Addendum 01

DOCUMENT 00 91 00

PROJECT: Clermont County Facilities Phase 2 Management Building
State Route 222
Batavia, OH 45103

This addendum form is a part of the Contract Documents and modifies the Construction Documents dated February 19, 2026, with amendments and additions noted below.

C1.3

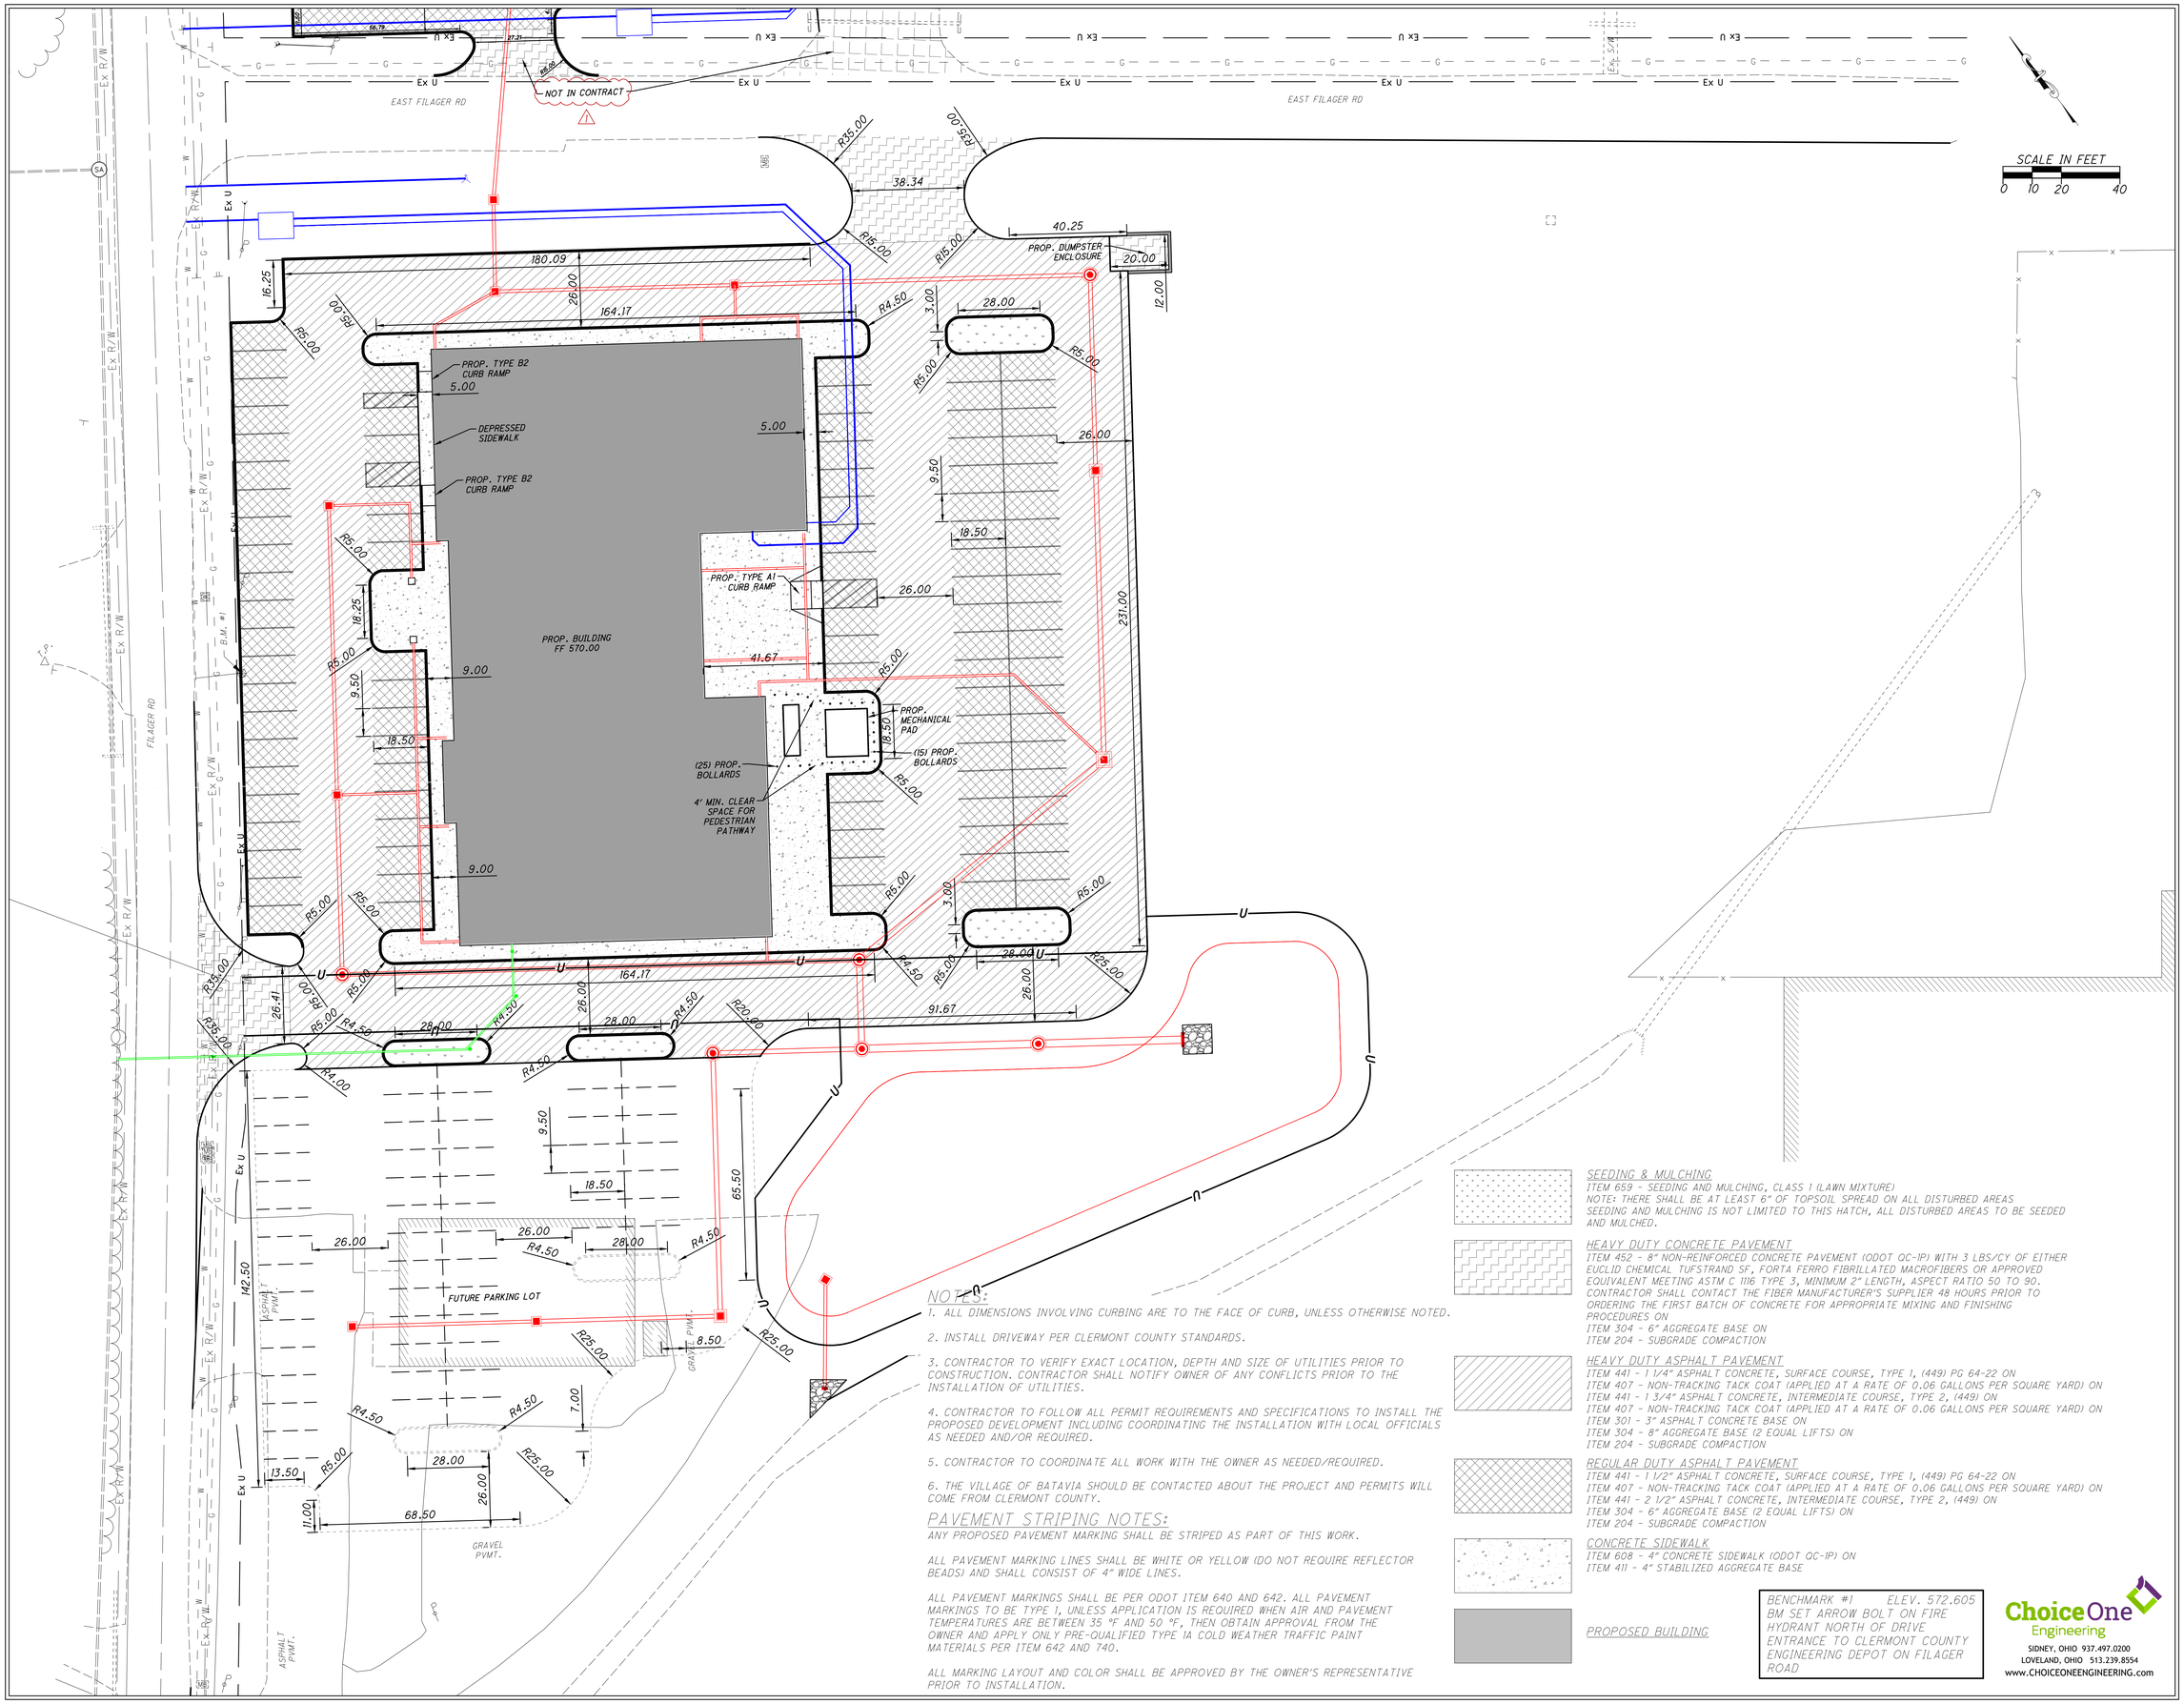
1. Drawing Sheet C1.3 Dimension and Pavement Plan - Note added that the CTC pavement for the Phase 3 project is not in this contract.
2. Drawing Sheet C2.1 Utility Plan –

SHEET NUMBER:
C2.1

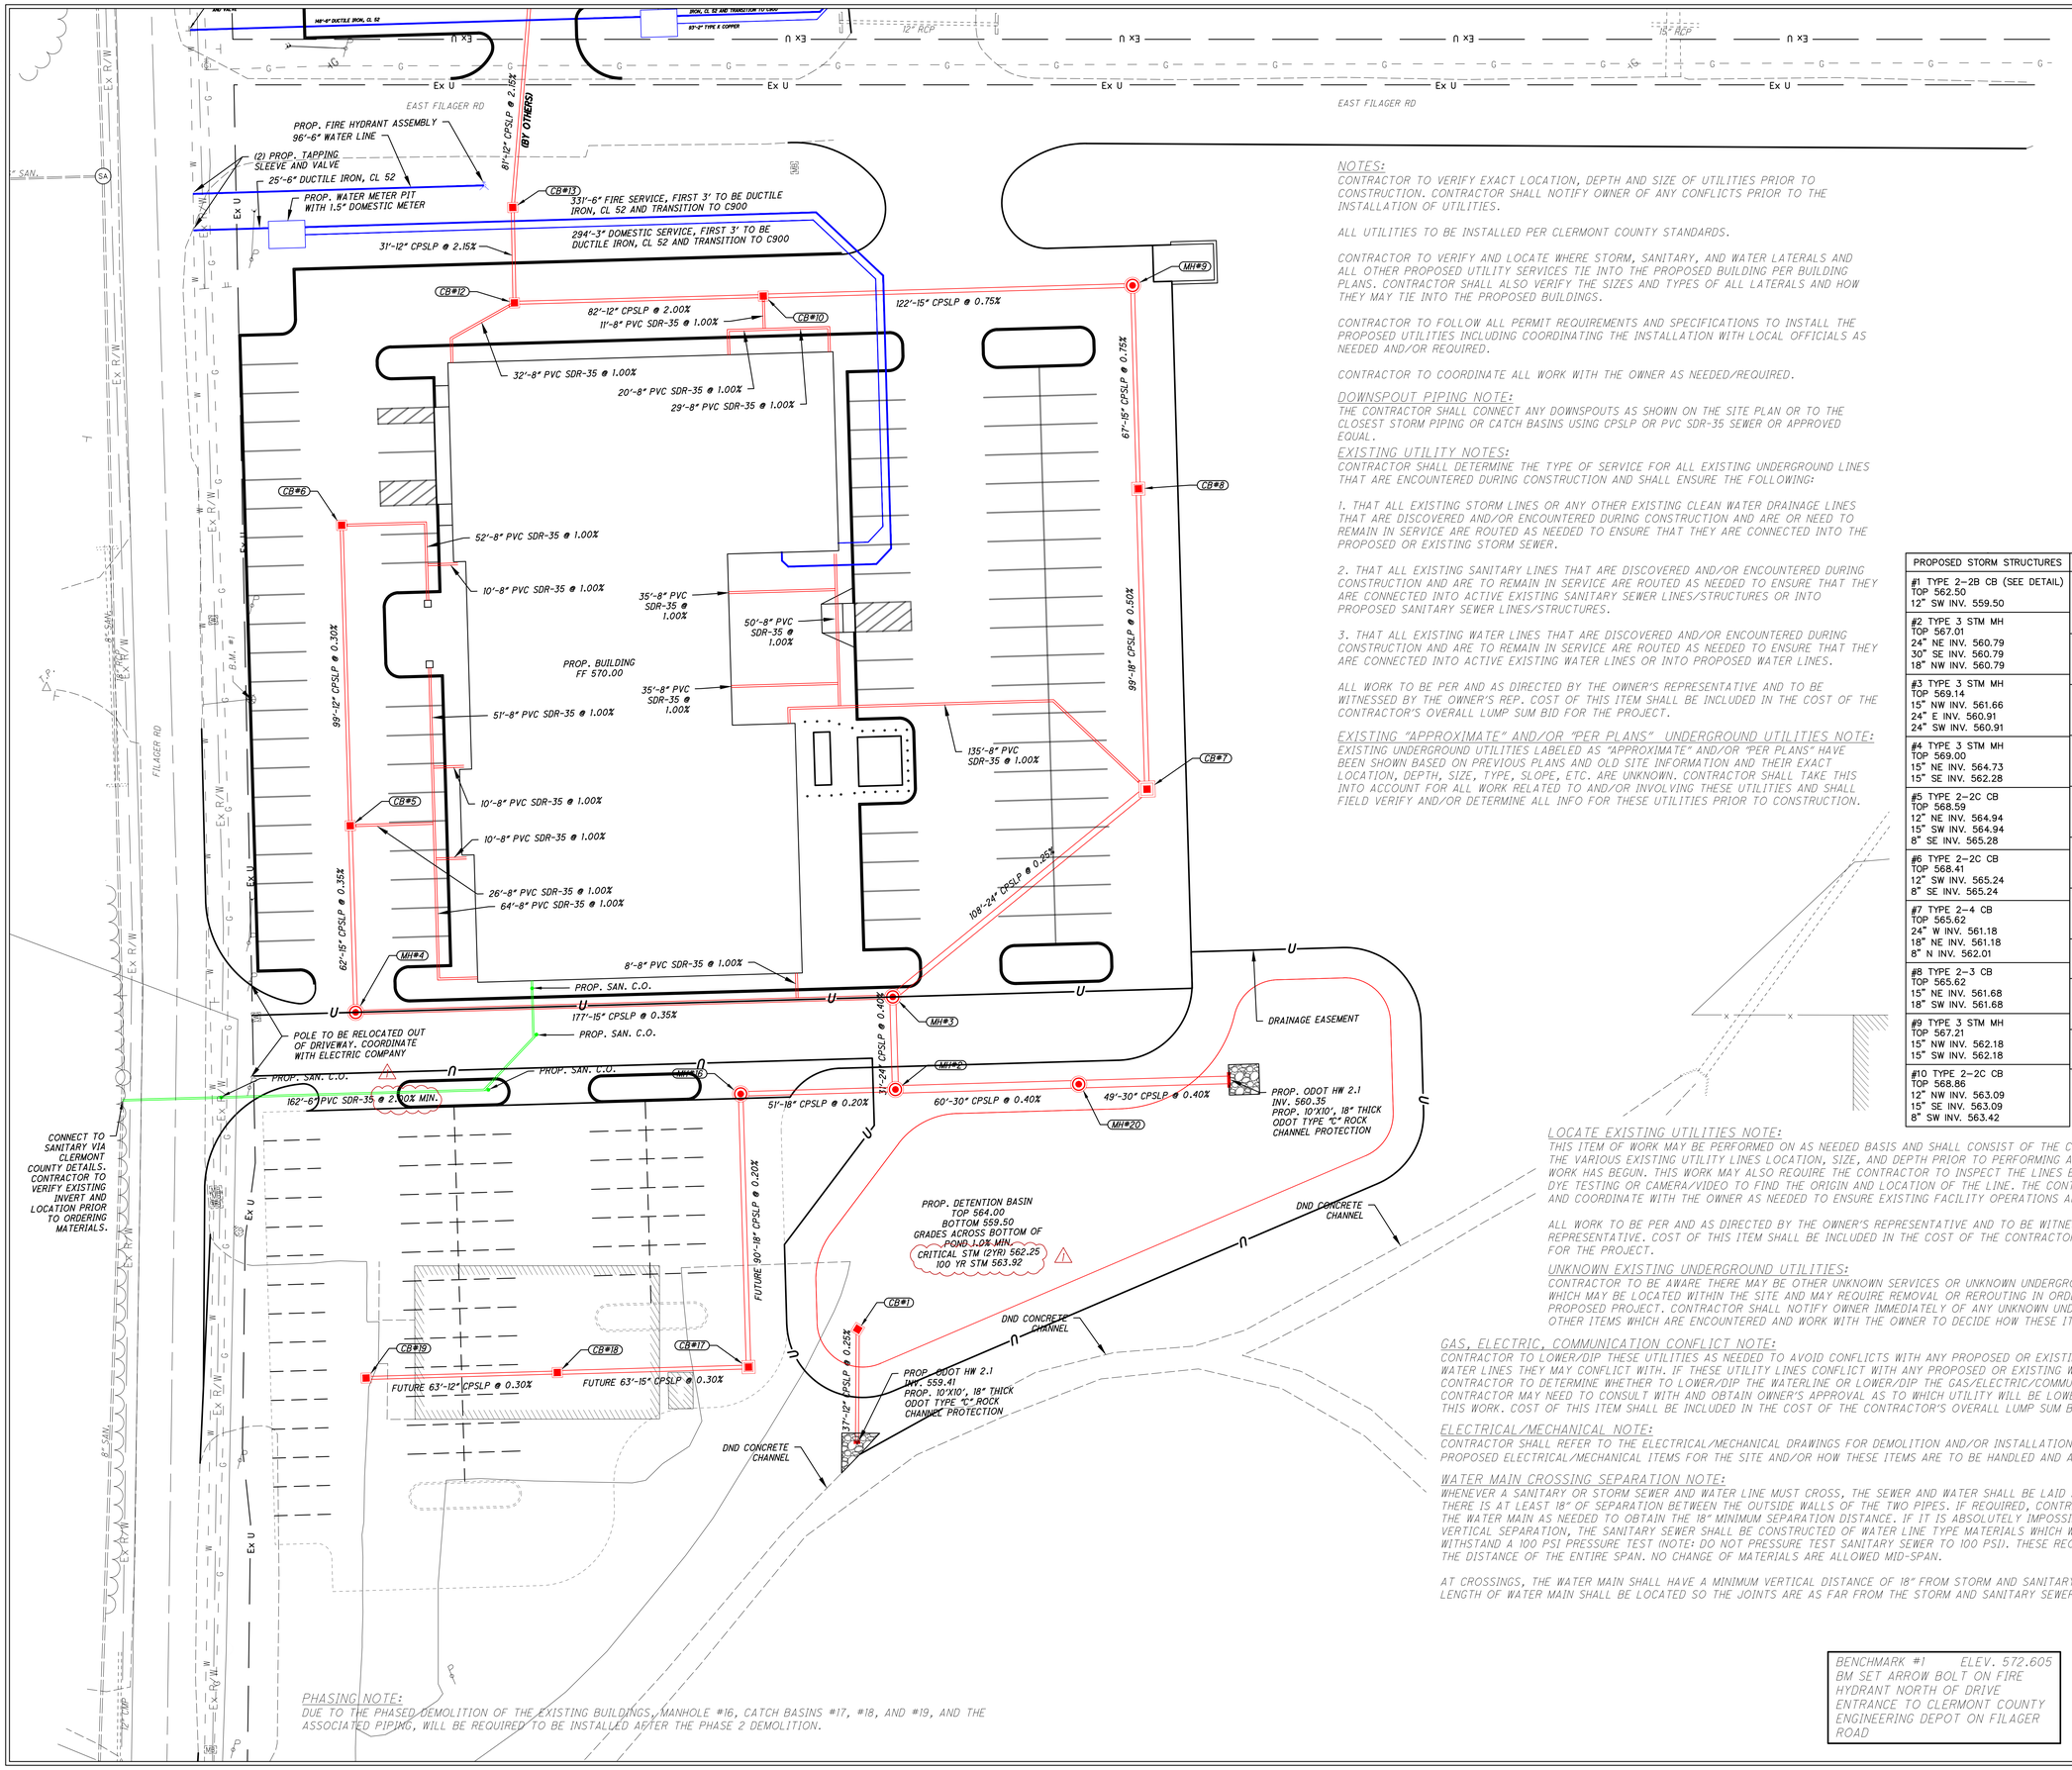
a. Sanitary lateral slope changed to 2.0% min.
   b. Elevations for critical storm and 100 yr storm added to detention pond text.
3. Drawing Sheet C3.2 Pavement Elevations Plan - More elevation call outs added to the Filager Road driveway.

1 A1.1 FIRST FLOOR PLAN
1/8" = 1'-0"

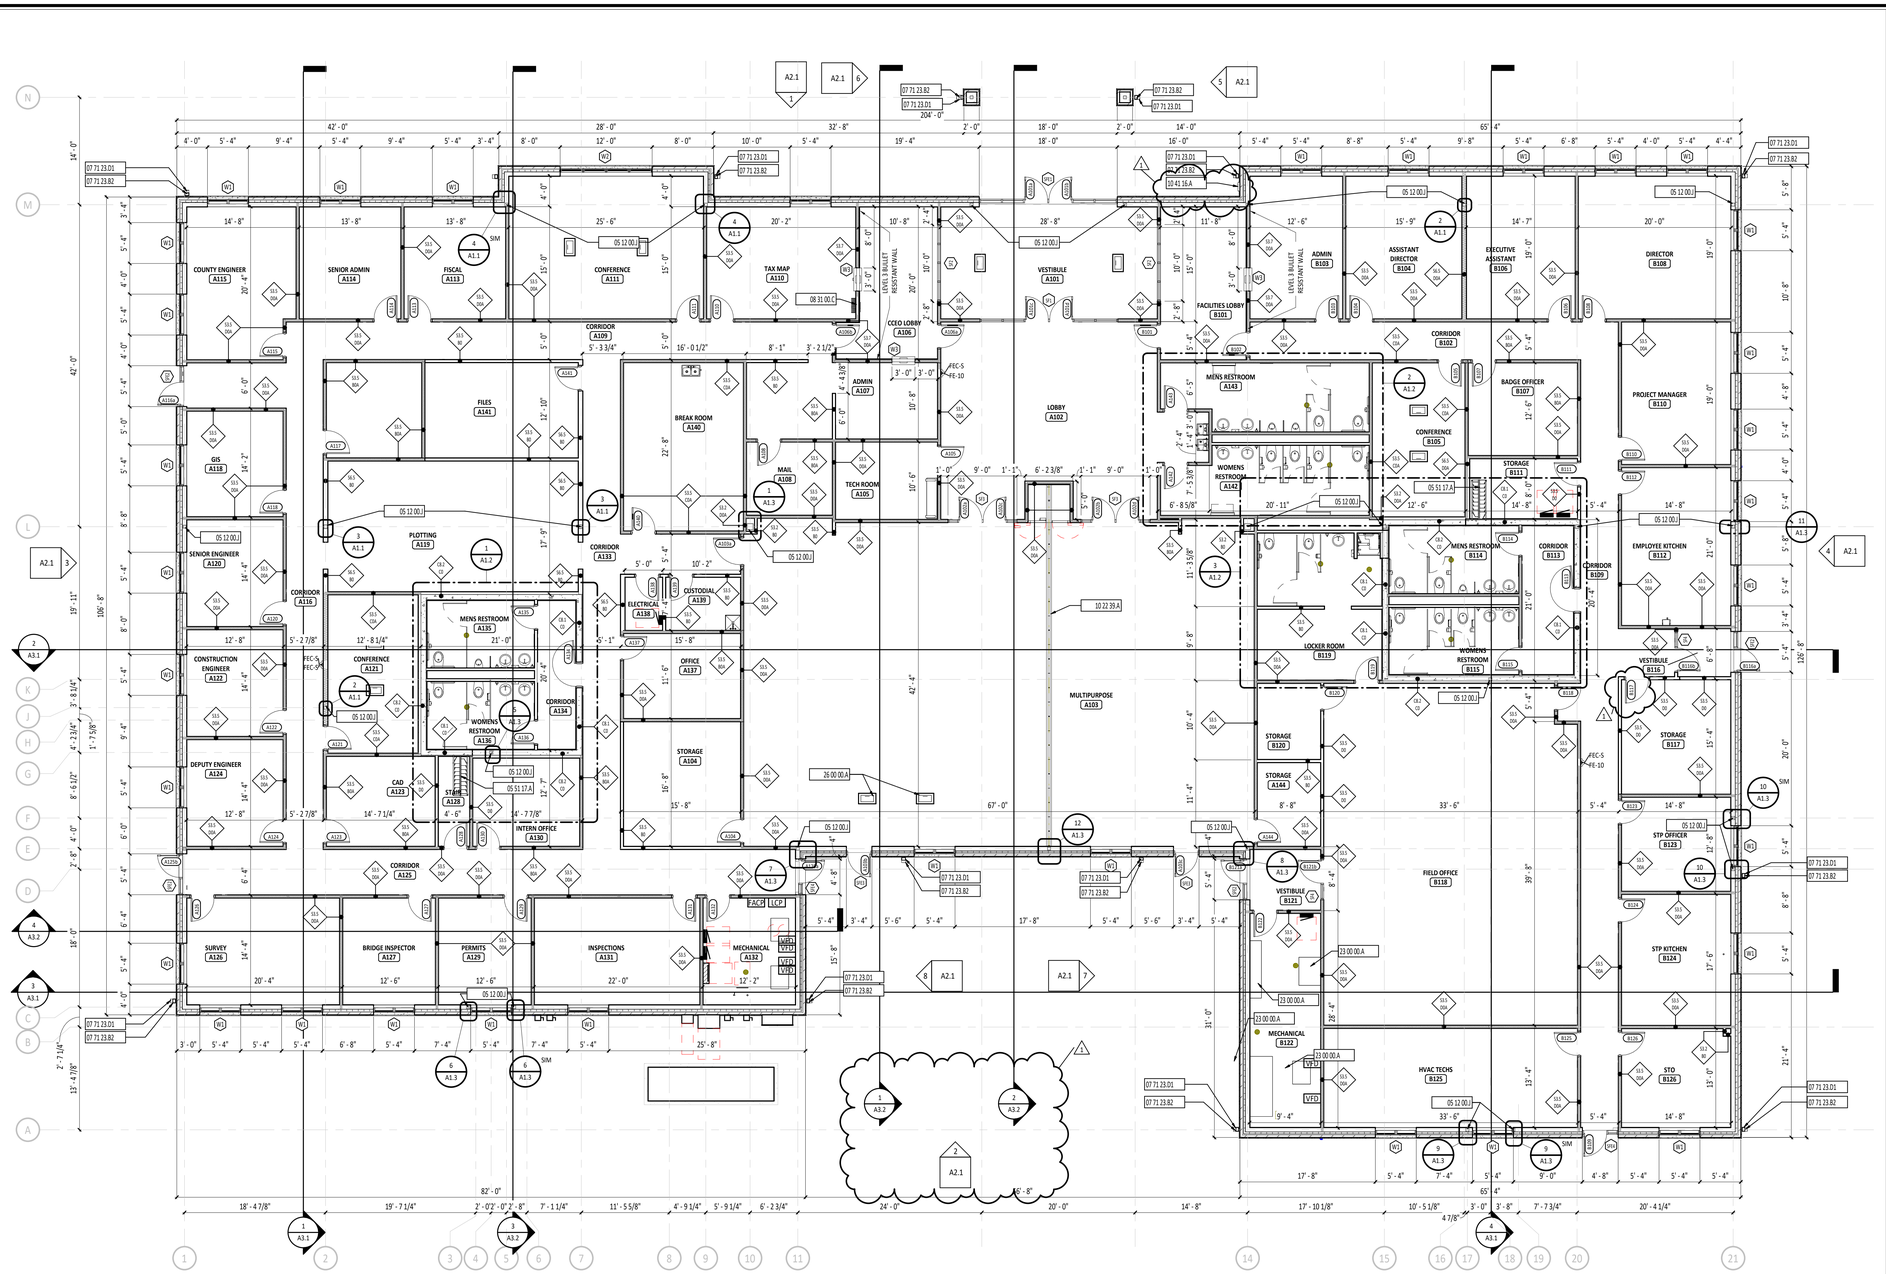
4. Drawing Sheet A1.1 First Floor Plan – Add knox box location, added elevation tags and building section callouts around building that reference other Architectural sheets. Removed duplicate A120 door, door should have been labeled B117.

SHEET NUMBER:
A1.2

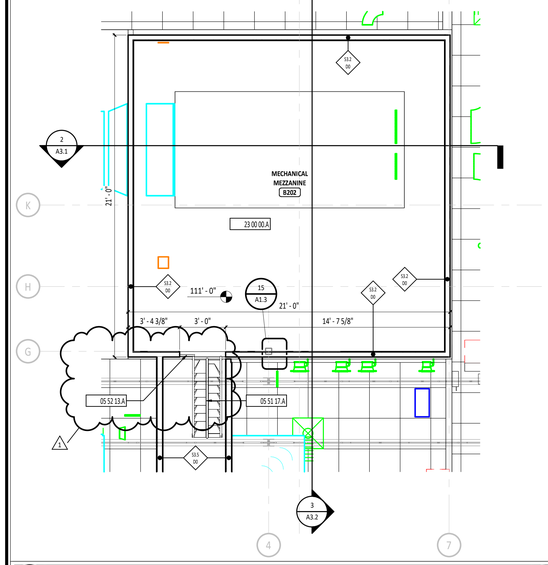
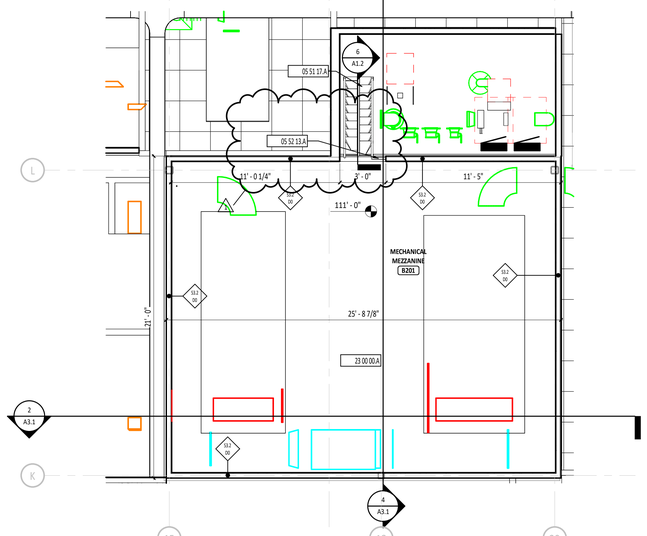
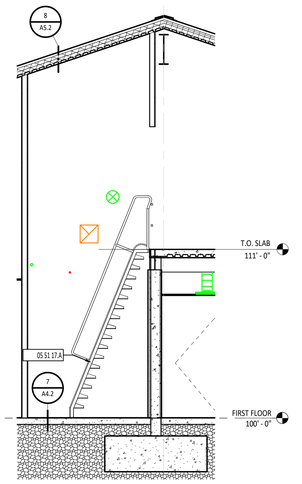
5. Drawing Sheet A1.2 Enlarged Floor and Mezzanine Plans – Add metal guardrail extension for alternating tread stair to close off gap in Mezzanine opening at both locations. Removed duplicate TA2.2 mirror designation in Toilet Accessory Schedule.
